TECHNICAL NOTE			
from:	ALAN DAVIES	date:	8/1/2022
subject:	Proposed dwelling with basement accommodation on an in-fill site adjacent to no 9 Old Road Chatburn 3/2021/1153	file ref:	J1050-TN1

This Technical Note sets out the response to the feedback.

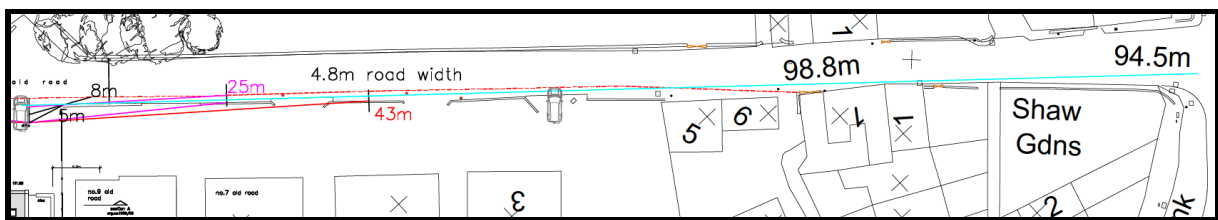
The LHA require a visibility splay drawing at the site access showing that the access can achieve the minimum vehicular visibility for a 30mph road, as defined in the LHAs guidance titled "Creating Civilised Streets."

In the LHAs guidance, the LHA require a new access directly off a 30mph road to achieve the minimum vehicular visibility of 2m x 43m in both directions. These should be shown on a revised drawing.

The LHA are aware that the 1.8m high fence will be located within the site's visibility splays. Therefore, the LHA remind the Agent that should a revised drawing showing the sites visibility splays be submitted and the LHA accept the drawing, the LHA will condition that anything within the splays is reduced to a height no higher than 0.9m to allow for vehicles to clearly view the public highway. This will include reducing the height of the fence.

The plan attached and the abstract below shows the 43m and 25m sight lines on the submitted plan. It shows these overlap the properties on either side as the current situation for all the drives along the section of the road. It also shows the 2*5m to channel and 2*8m to 1m offset sight lines as delivered.

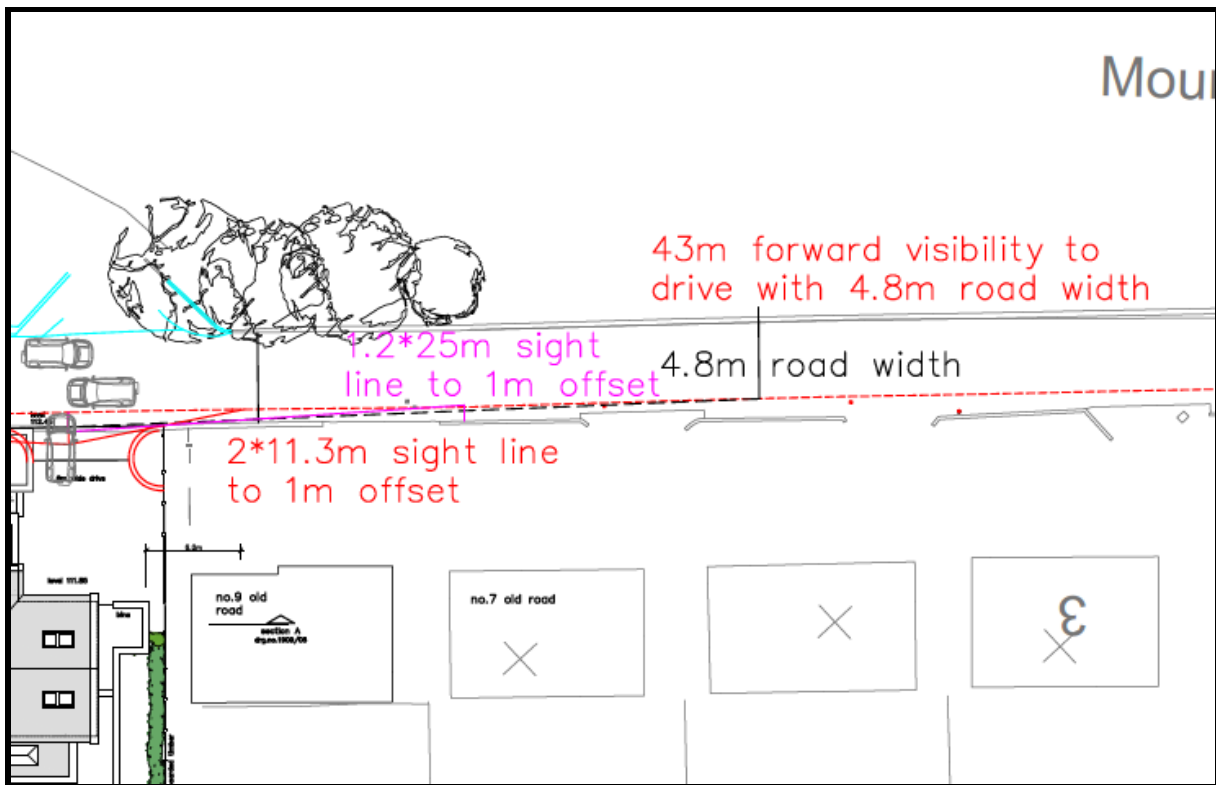
For the LHA to consider accepting the visibility splays below those identified in the guidance titled "Creating Civilised Streets," a speed survey demonstrating the 85th percentile speeds should be submitted.

Description	85th Percentile Speed	a = longitudinal gradient (%) (+ for upgrades and - for downgrades)	Stopping Sight Distances in metres. Not including 2.4m for bonnet length when assessing the forward stopping sight distance of a vehicle travelling along the carriageway.				
			Parameter	Highway Code	TRL Safety Report 332	MfS 2 HGVs greater than 5%	MfS Section 7.5.7 Desirable minimum
			t = driver perception - d = deceleration	0.68	0.9	1.5	1.5
			6.57	4.4145	4.41	4.41	
Westbound 30mph	30.0	11	13.41	21	28	36	36
Westbound 25mph	25.0	11	11.17	16	21	28	28

The form indicates a reduced safe stopping Distance on the uphill approach, this combined with the adjusted drive location and the ability to ensure no wall/shrub etc exceeds 1m across the site frontage meets the historic stance made by lcc.
